RE: SEPTA South Broad ADA Improvements – Lombard-South Station – Revised Per 4/10/24 Comments

**LOMBARD-SOUTH STATION
ADA IMPROVEMENTS**

PHILADELPHIA ART COMMISSION PRESENTATION

ENLARGED PLAN NE CORNER HEADHOUSE

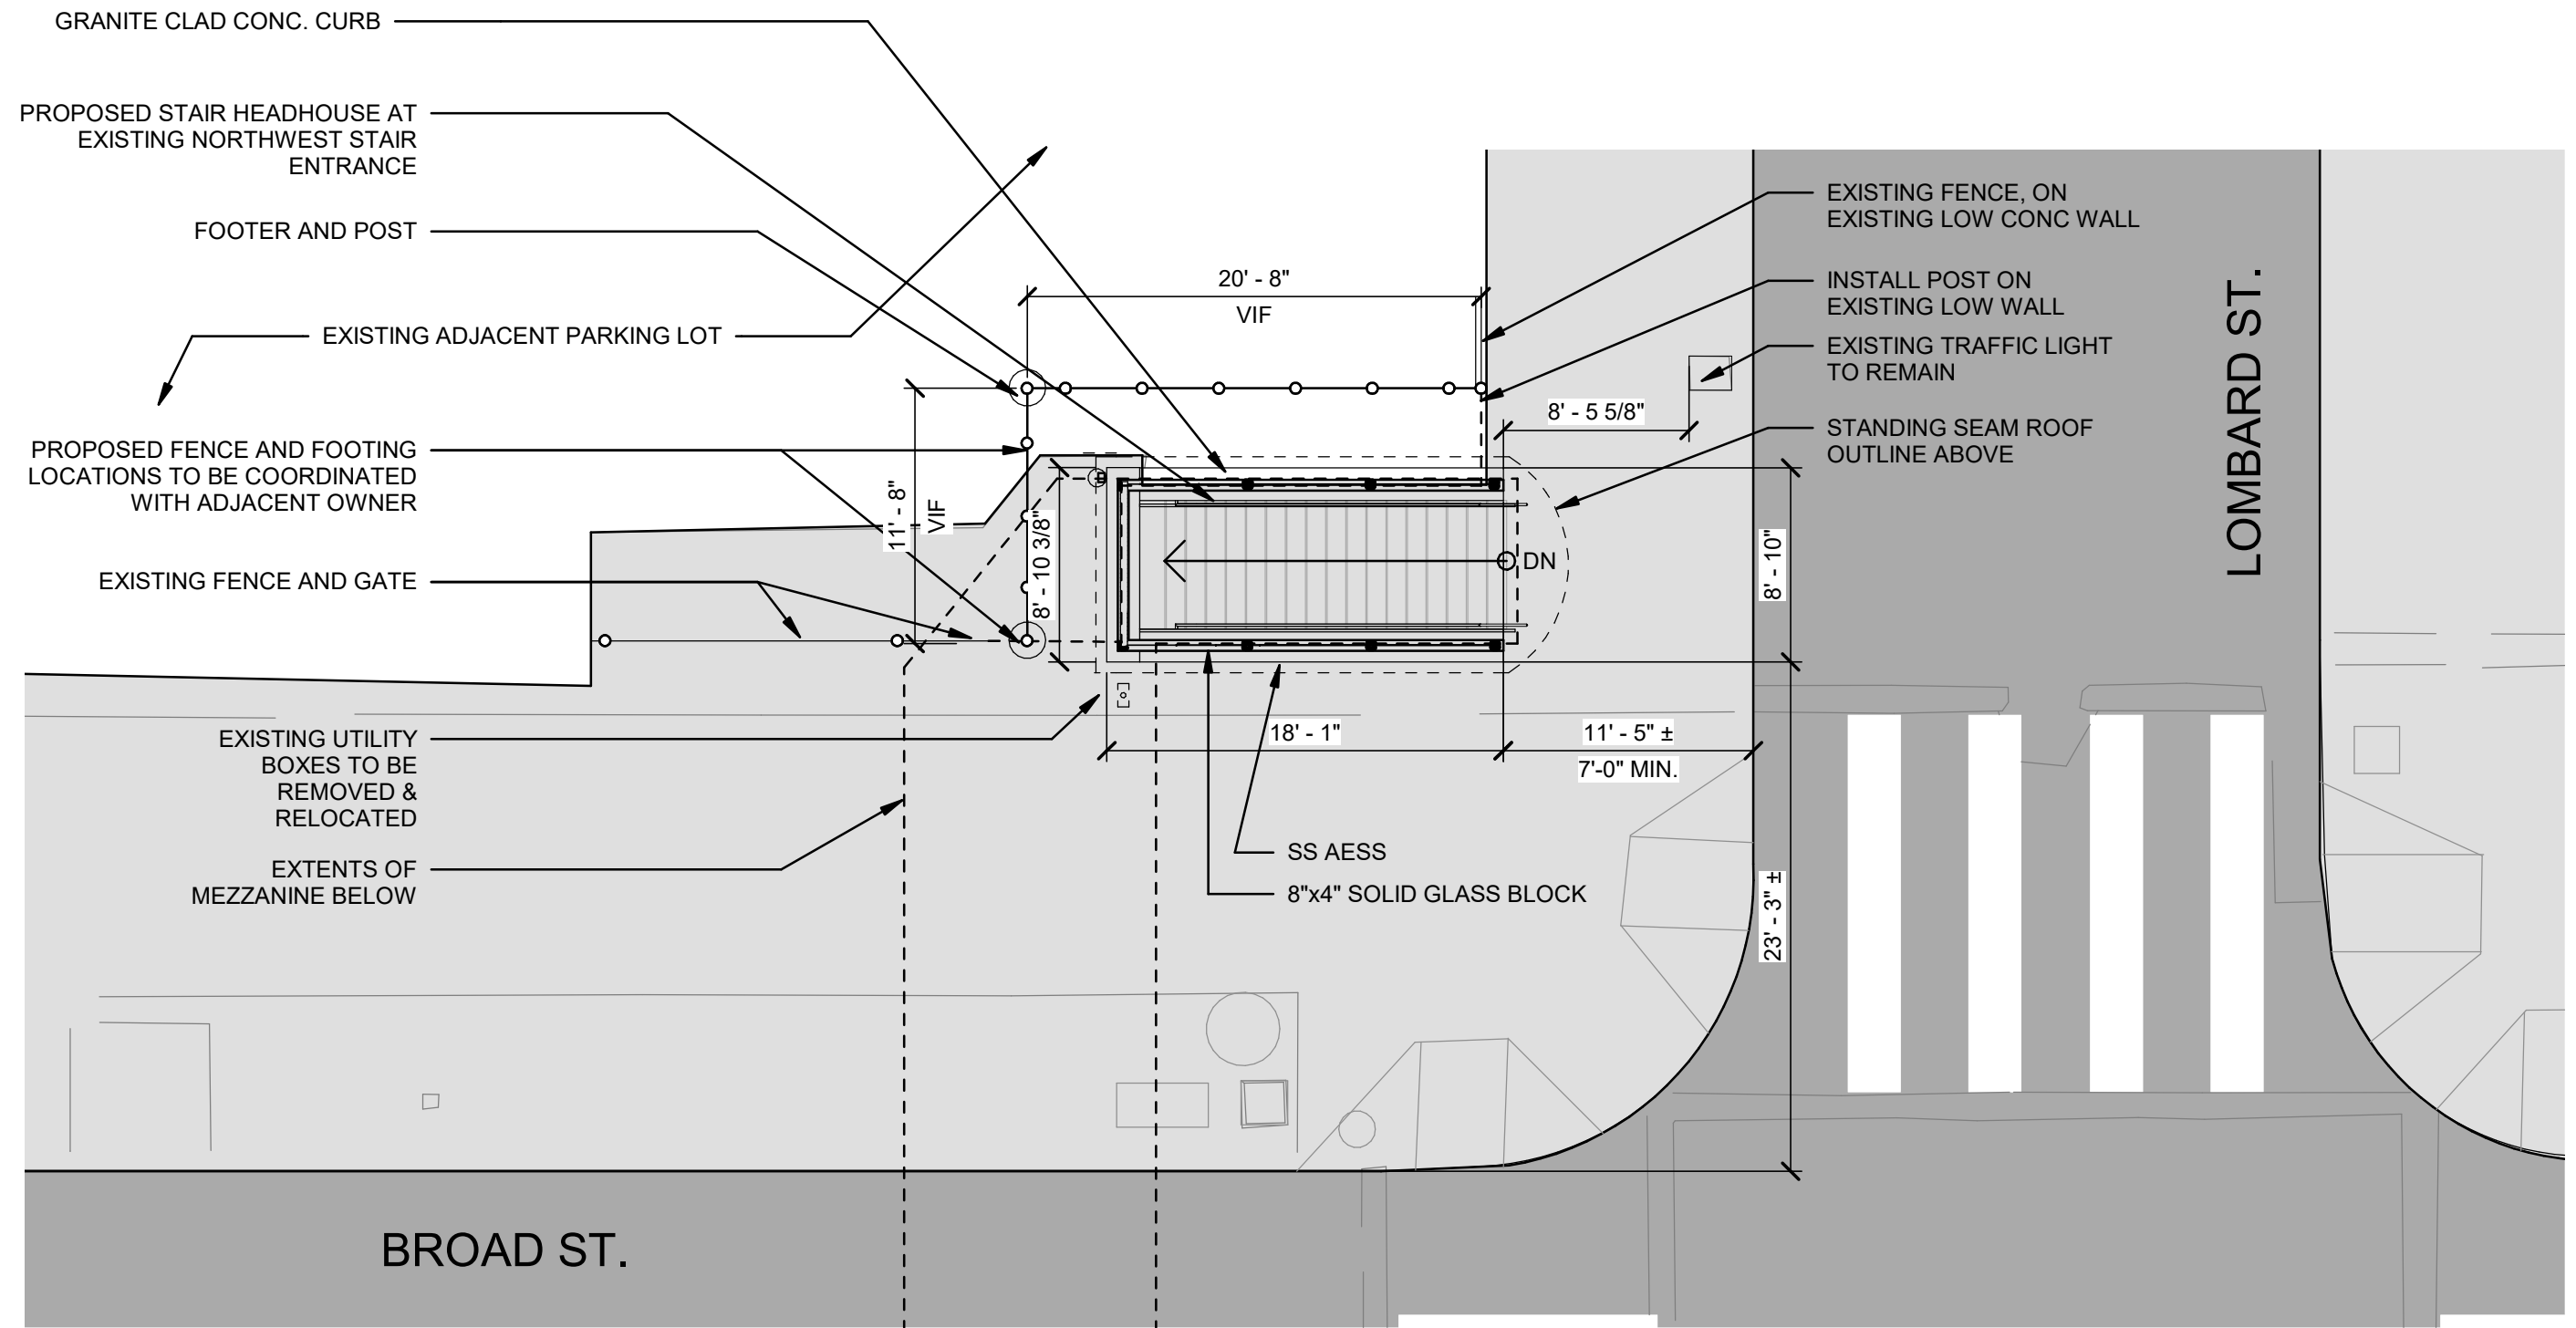
With the relocation of the gate on the NE & NW stairs down to the intermediate landing, the canopy structure length has been reduced by roughly 4'-0", see revised sheets A-9 and A-10. This reduction of length provides additional clear width to the existing ADA curb cut ramp on the NE corner and additional clear width to the existing traffic light on the NW corner.

STAIR HEADHOUSE TYPICAL ELEVATIONS 1

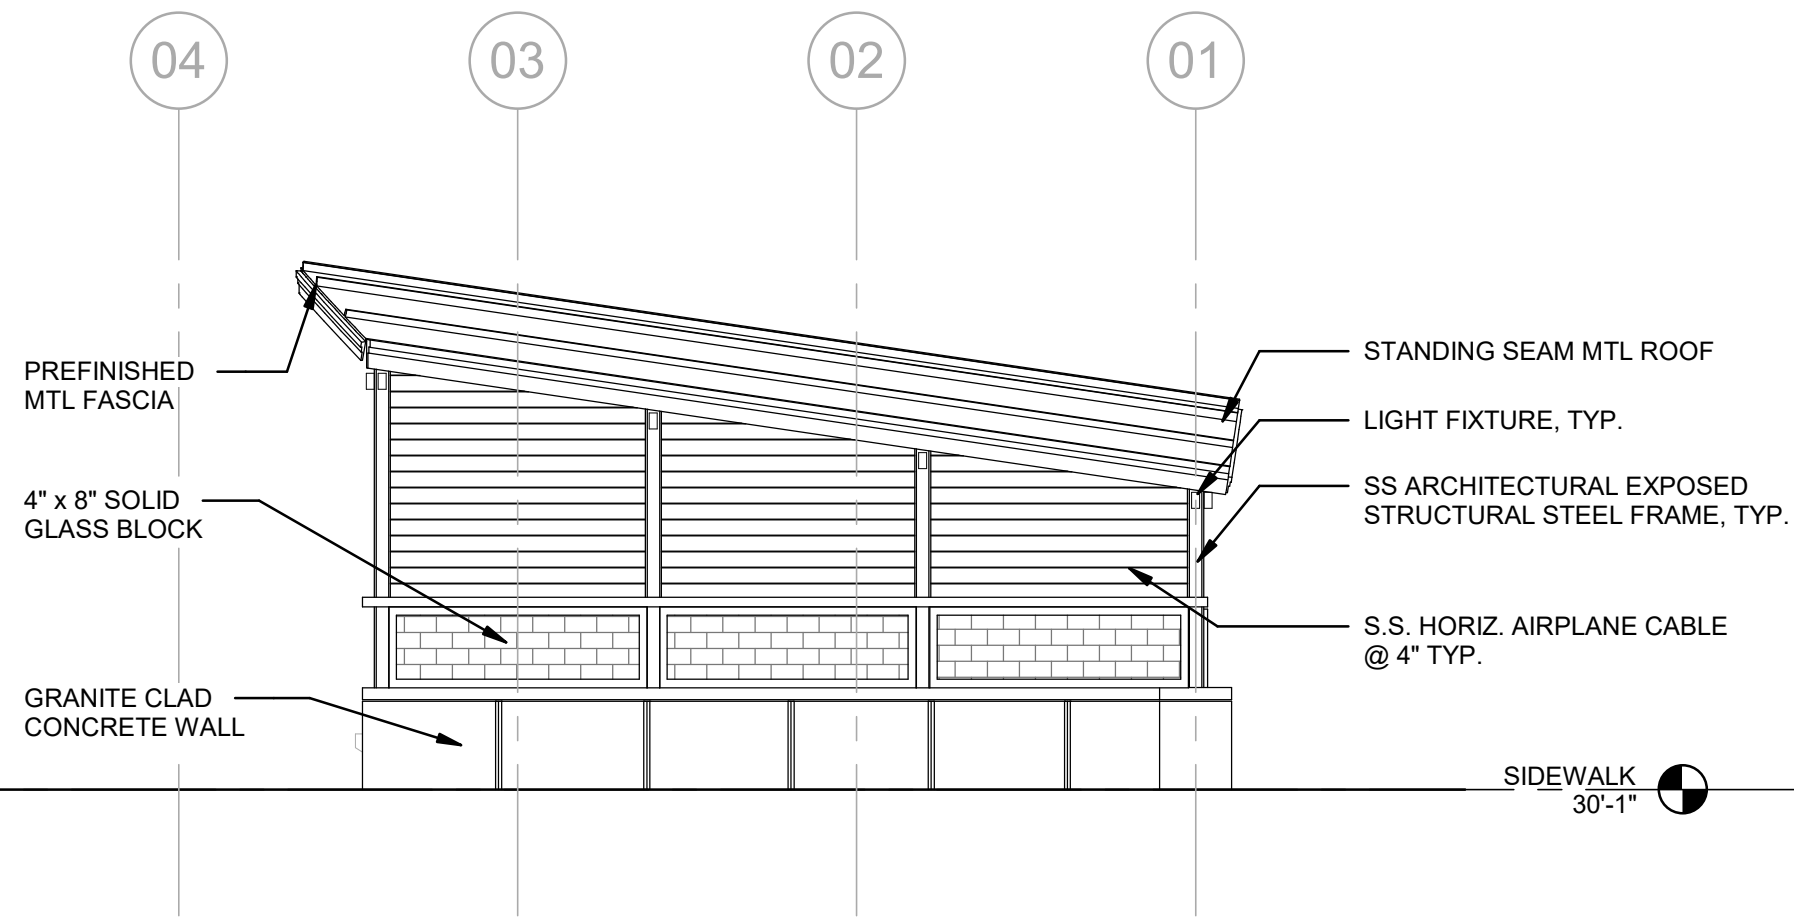
Existing LED monitors by 'Intersection' will be salvaged and reinstalled, at similar locations and heights using similar stainless steel tube supports as approved throughout at several of SEPTA's other stations. At Lombard-South, the monitor at the NE stair will be supported by a horizontal stainless steel tube member spanning between two posts for the new roof canopy. See revised sheets A-16, A-16a, A-25, A-26, A-26a.

Downspouts have been removed at stair NE & NW Stair canopies. See revised Sheets A-25, A-26.

MATERIALS PALETTE
LOMBARD-SOUTH STATION

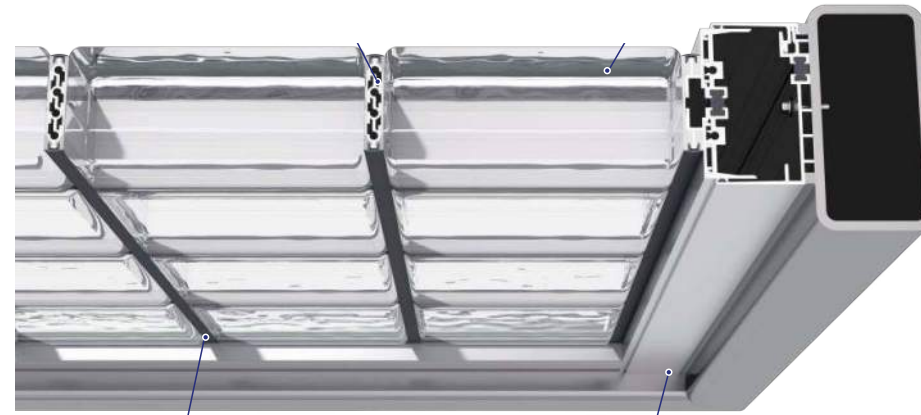
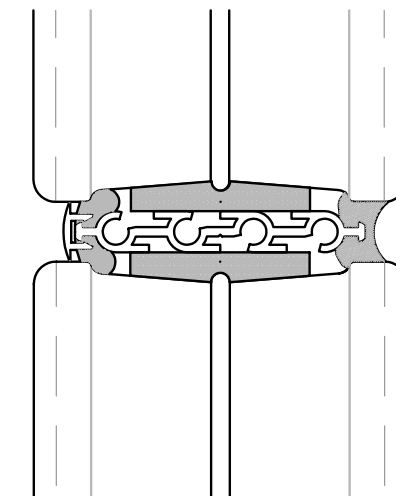
See updated materials palette on sheet A-28. The granite color and pattern has been revised to match existing.
